Bluff Stabilization
At 1025 Hardy Road, Painesville
KS Project No. 24072

DATE OF ADDENDUM: January 31, 2025

ADDENDUM NUMBER: 02

TO THE DRAWINGS AND SPECIFICATIONS FOR:

PROPOSED SITE PLAN
BLUFF STABILIZATION
AT PAINESVILLE PARK
 LAKE COUNTY
 1025 HARDY ROAD,
 PAINESVILLE TOWNSHIP, OHIO 44077

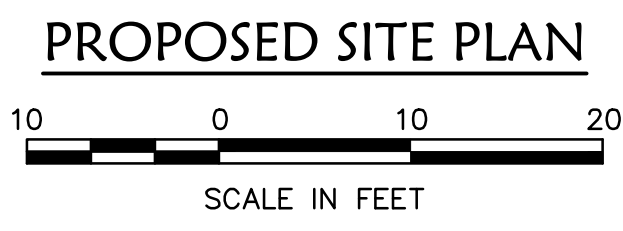
Sheet 4 appears to show the light pedestals within the rock drain channel. Is this correct or should the edge of the channel be offset to outside of the pedestal foundations?

Sheet 4; it appears that the 10ft wide drainage channel dead-ends at the Redi-Rock wall. Is that the case or does it discharge into the new 4" PVC? If so what is this transition intended to look like?

Sheet 4 shows to seed and mulch existing slope with native flowering plants. 02 09 30 - 2.1.1 calls to seed with ODOT 659.09. Is that the intent of the note and is it the entire existing slope East of the stairs or only disturbed areas?

For the concrete modular block wall: Spec 32321 - 2.5 calls for the drainage pipe to be 4" 3-hole perforated HDPE Sheet 4/11 calls for 4" perforated PVC behind the wall. Sheet 4/11 calls for 4" perforated PVC daylight to the lake - should this be solid and / or HDPE? Sheet 6/11 Notes calls for 6" corrugated, perforated plastic with geotextile.

For the Rock Drain Channel: Sheet 4/11 shows 4" PVC. Sheet 6/11 shows 4" Perforated PVC. Sheet 8/11 shows 4" PVC pipe. Please clarify size, type and if geotextile/sock is required for both drainage pipe applications.

The rock channel should be offset to the east from the edge of the pedestal foundations.

The rock channel discharges into the existing catch basin. The modular block wall has been revised to include freestanding blocks to prevent interference with the existing catch basin.

Seeding and mulching is only required in disturbed areas.

The Redi-Rock drainpipe can be either the HDPE pipe from the spec or a perforated 4" PVC pipe as shown on the drawings. The pipes that daylight to the lake shall be solid. This has been updated on Sheet 4.

The Rock channel drainpipe behind the sheet piling should be a 4" perforated PVC pipe. Sheets 4 and 8 have been revised to specify perforated drain pipe. All perforated pipes shall be geotextile wrapped.

ELEVATION VIEW
BLUFF STABILIZATION
AT PAINESVILLE PARK
 LAKE COUNTY
 1025 HARDY ROAD,
 PAINESVILLE TOWNSHIP, OHIO 44077

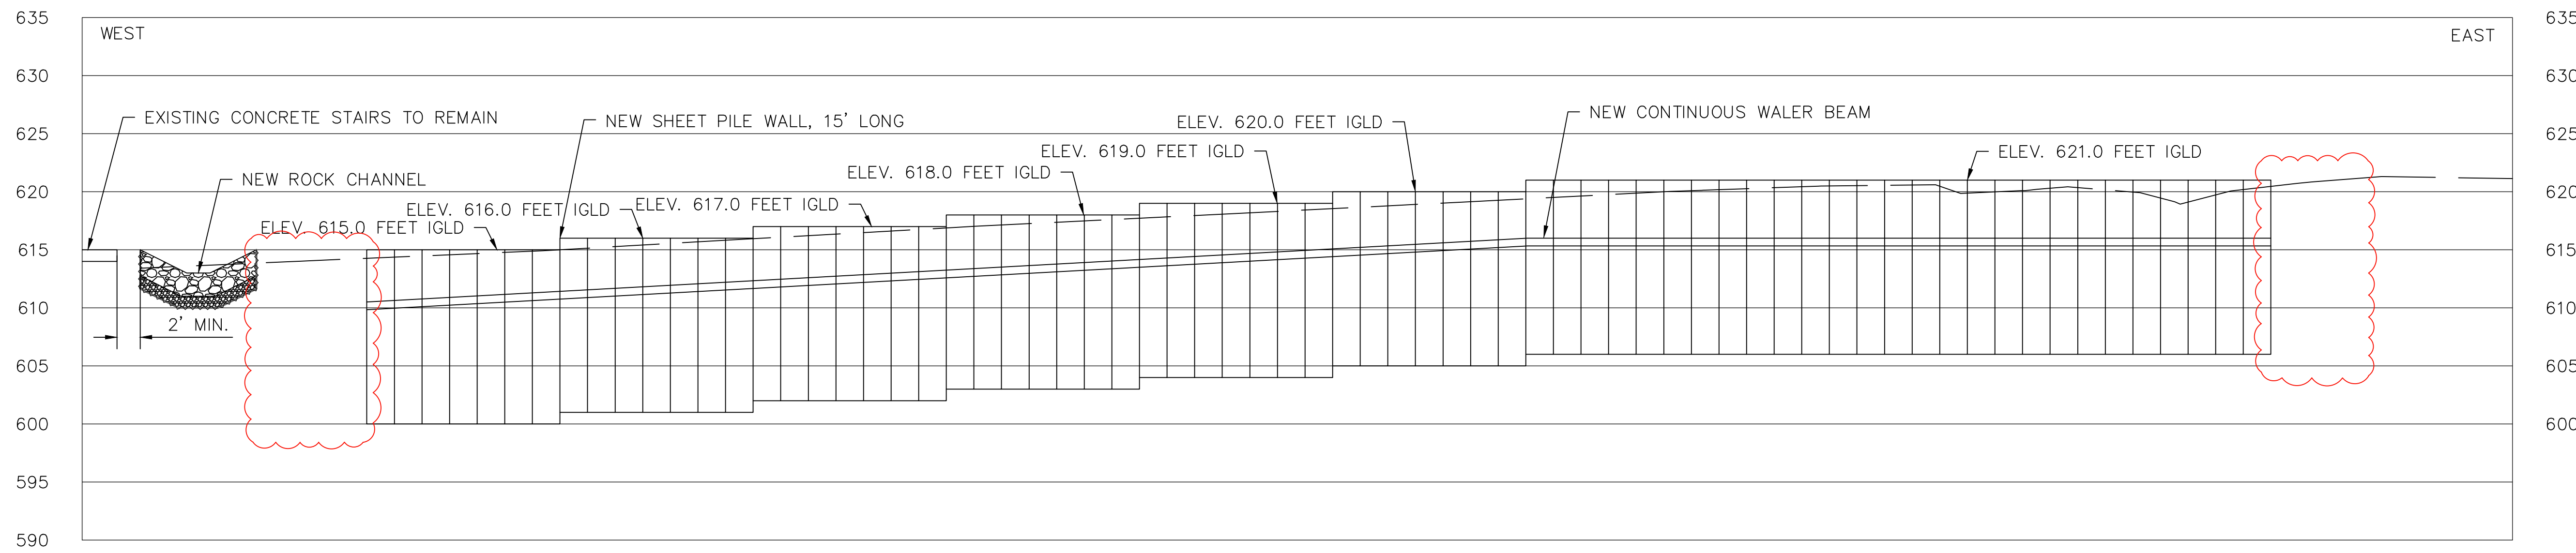
When I calculate the length of the sheet pile wall using the location points on sheet 5 I come up with approximately 175 linft of wall but if I scale the elevation view on sheet 7 and/or count sheets and multiply by the sheet width of 28.5" I come up with approximately 185 linft.

Can you clarify which is correct?

There are 35 pairs or about 166.25 linear feet of sheet piling.

WALER SHEET PILE CONNECTION DETAIL

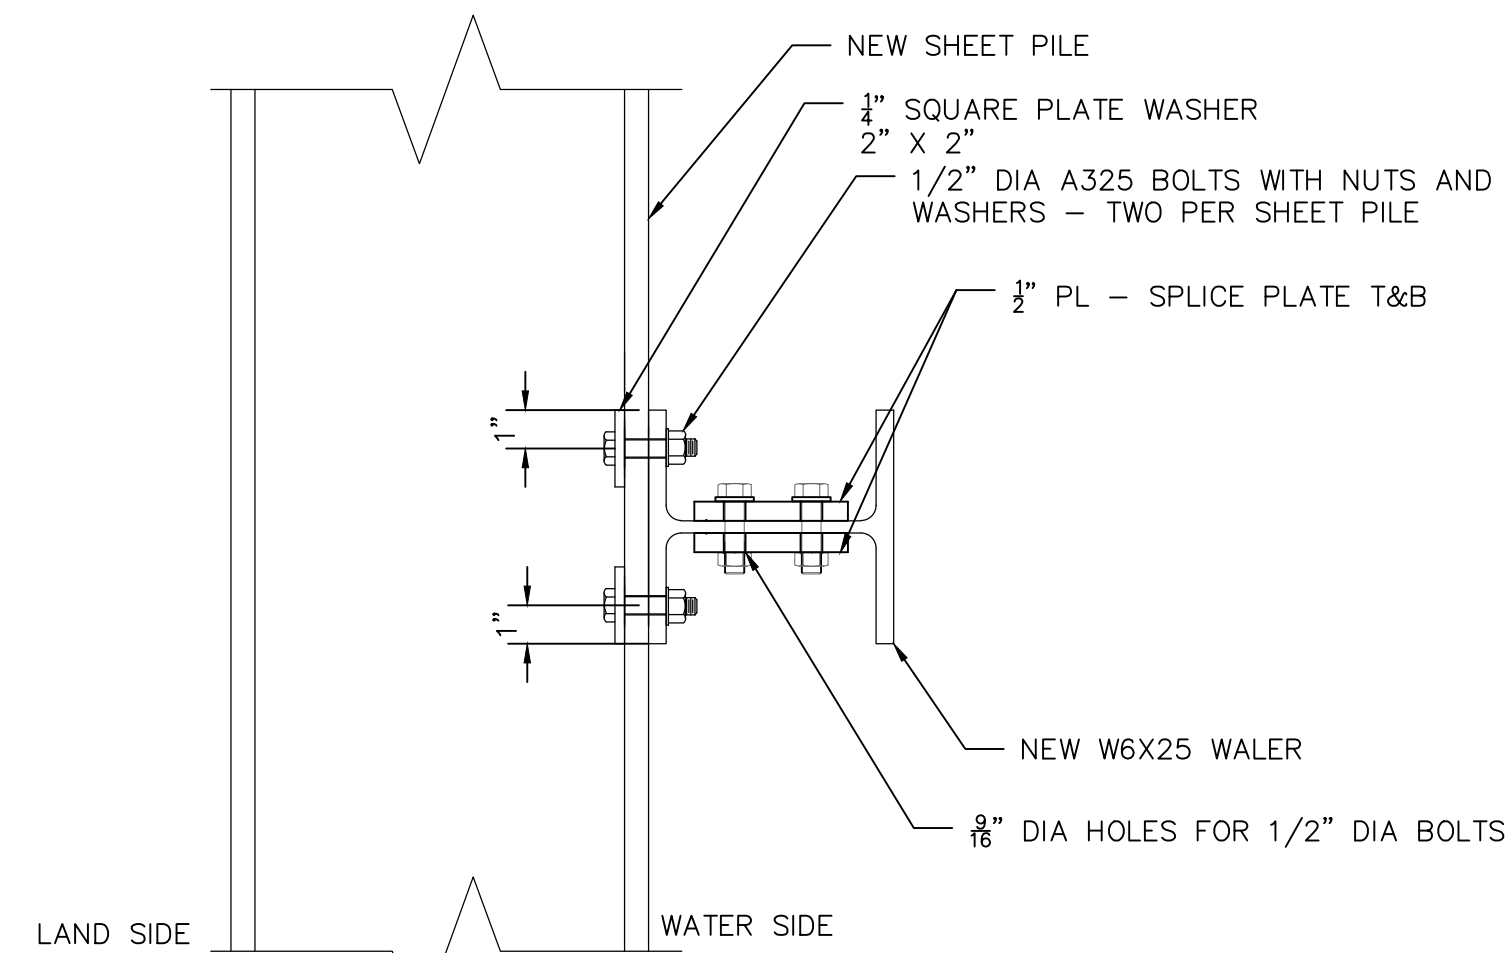
Sheet 6/11 Section A-A shows the waler on the "Northern" face of the sheet pile wall 5ft below top of sheet within the temporary excavation limits bolted to the face of the sheets. Sheet 8/11 Waler Sheet Pile Connection Detail shows the waler beam mounted on the Land Side which would be the "South" side. Please clarify.

Sheet 6/11 shows the limits of excavation only on the water side of the sheets. Should there be excavation limits defined on the Land Side of the sheets to allow for installation of the water bolts? Should any fill installed on the Land Side be premium? If so what fill material should be used?

Sheet 8 has been updated, the “water side” and “land side” labels were corrected. The design intent is for the water to be on the “water side” of the sheet piling.

The detail on Sheet 8 has been updated to allow welding the water beam to the sheet pile, no excavation should be required on the land side of the sheet piling.

1. VERTICAL DATUM IS IGLD85.
2. THE CONTRACTOR MAY EITHER BOLT OR WELD THE WALER BEAM TO THE SHEET PILING.

GRAVITY BLOCK RETAINING WALL KEY/COUNT

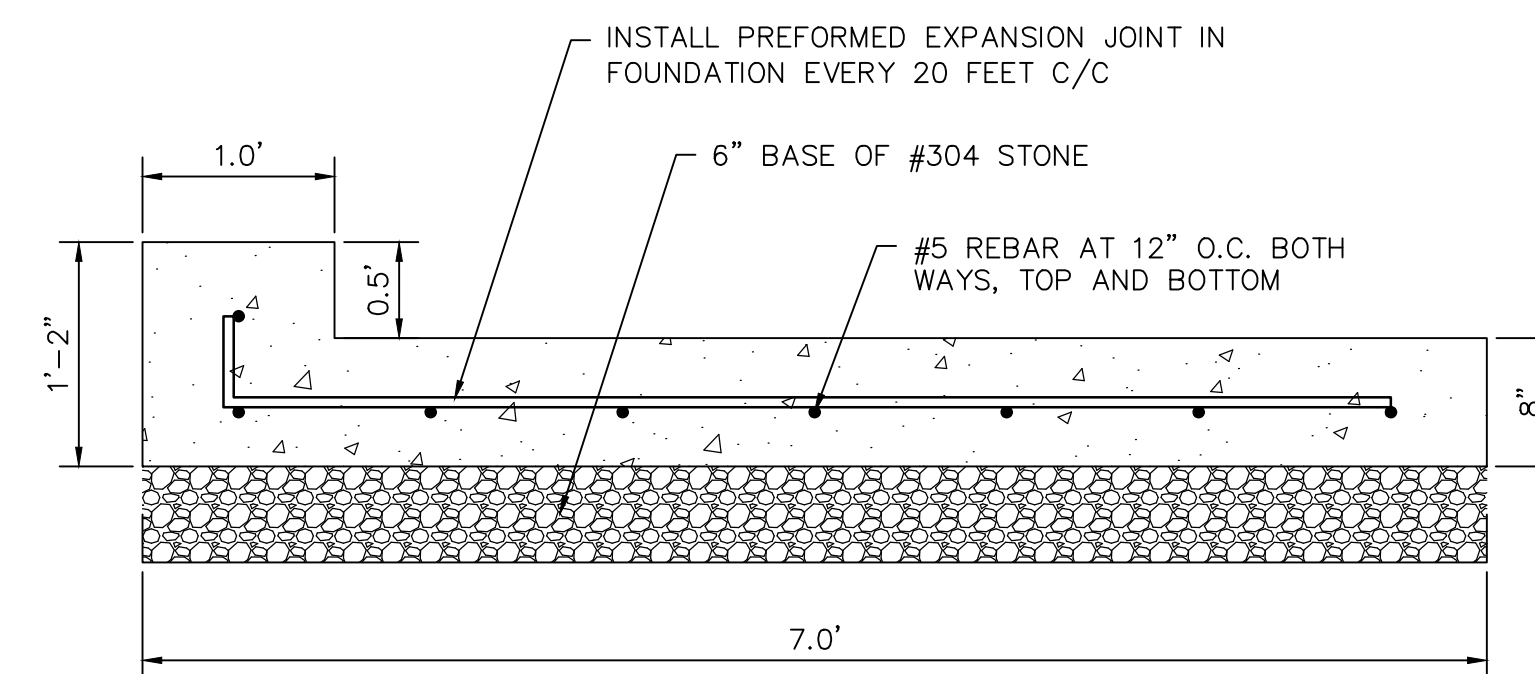
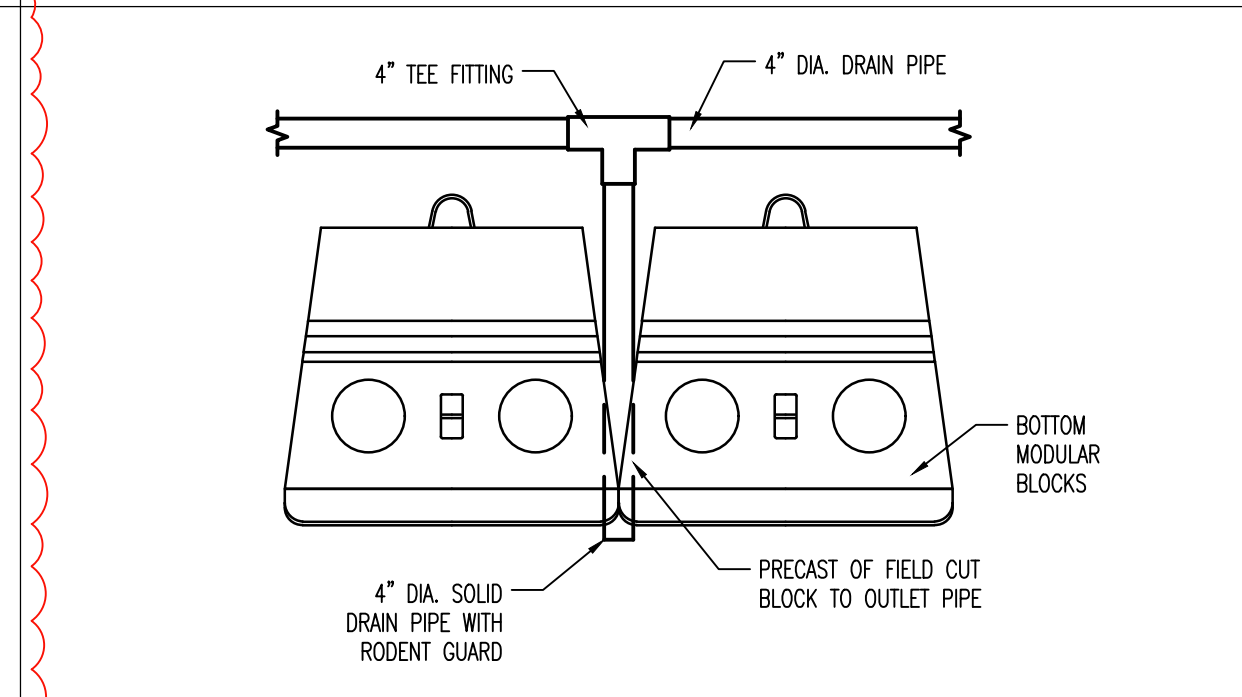
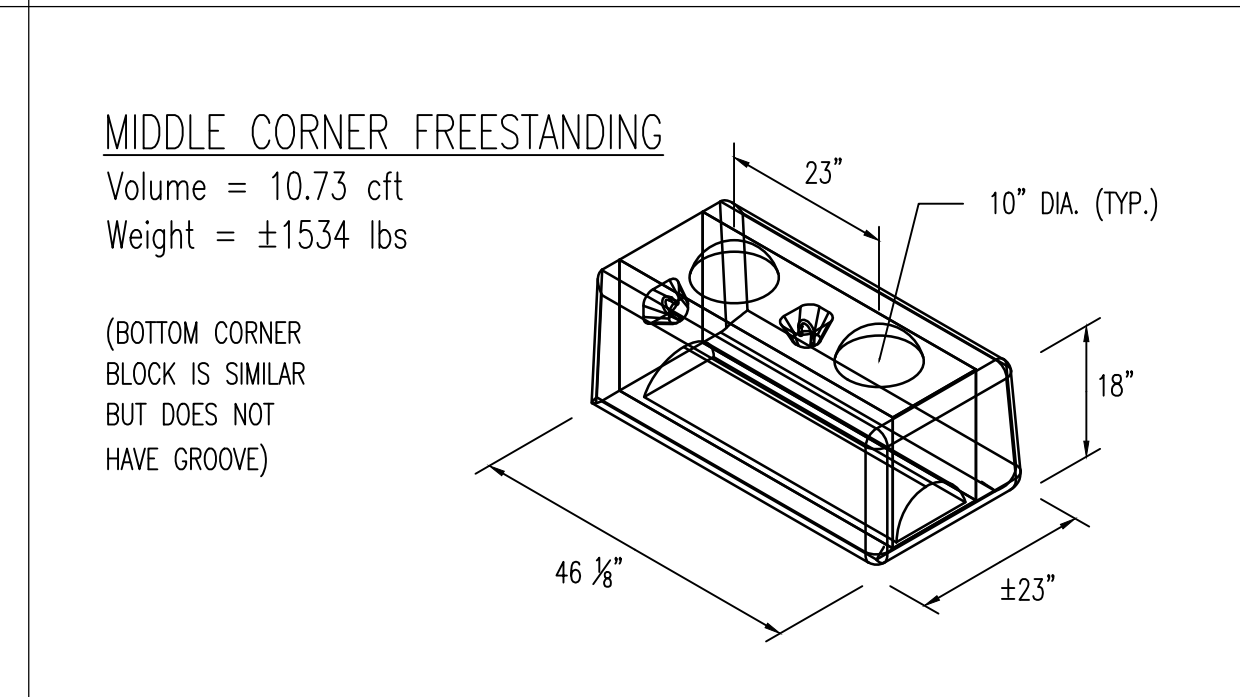
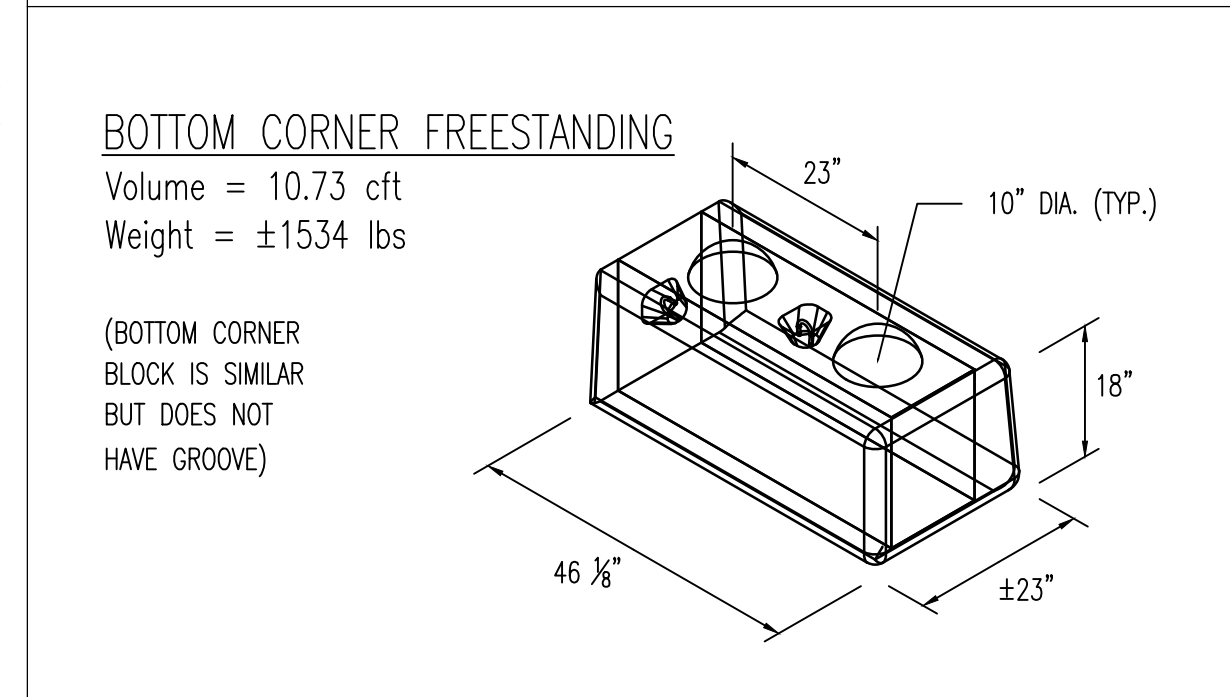
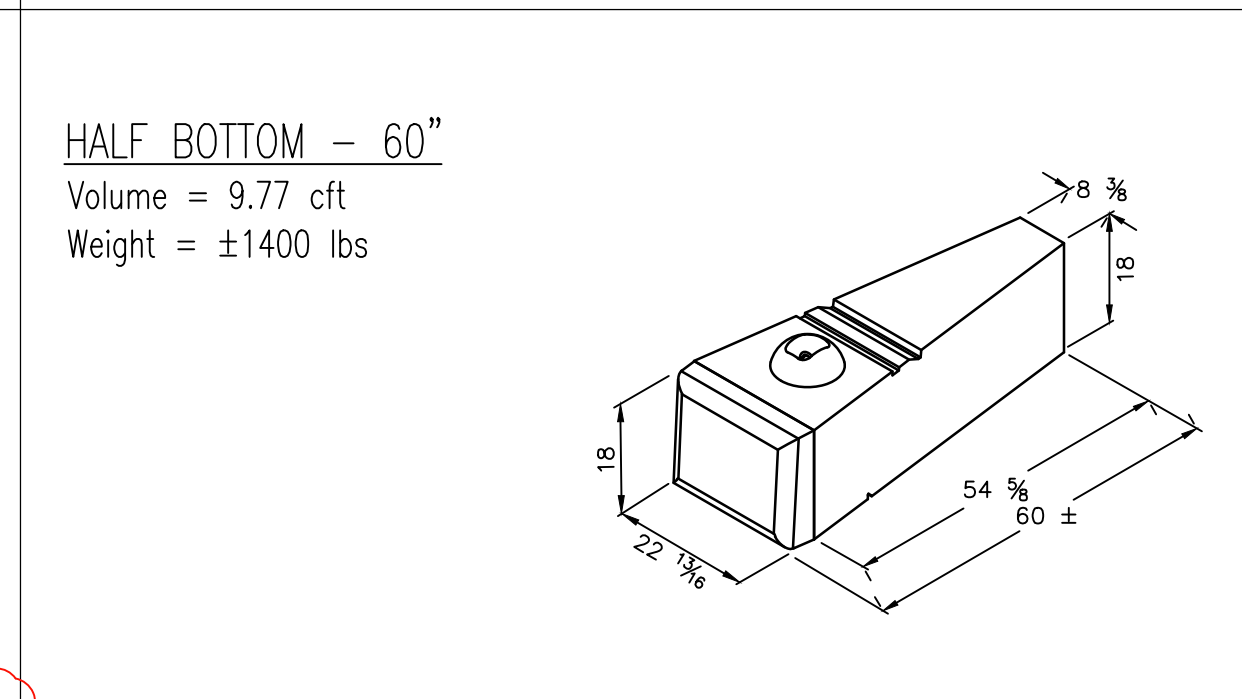
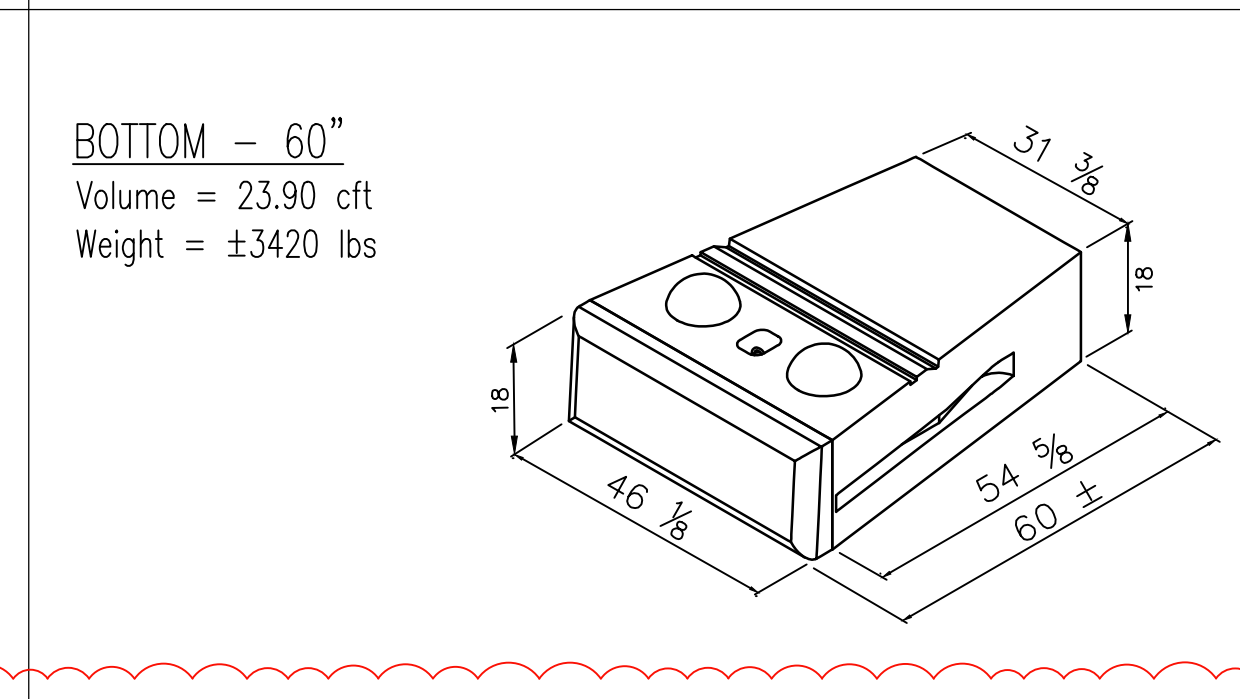
Sheets 3 & 4 of 11 shows details of existing Catch Basin 40530 which is within the limits of the proposed Redi-Rock Wall. The rim of the catch basin exists at 584.10 but the sub grade of the Redi-Rock wall footing is 582.34. What is to take place here? Is the catch basin to be removed/abandoned? What, if anything, is to happen with the existing 4" from this catch basin that ties into the existing 12" PVC outfall?

The new rock channel shall drain into the existing catch basin. The concrete modular block wall in this area has been revised to include freestanding blocks with a shorter foundation to avoid conflict. The drain stone behind the concrete modular block wall will be omitted in this area. The block count on Sheet 10 has been updated.
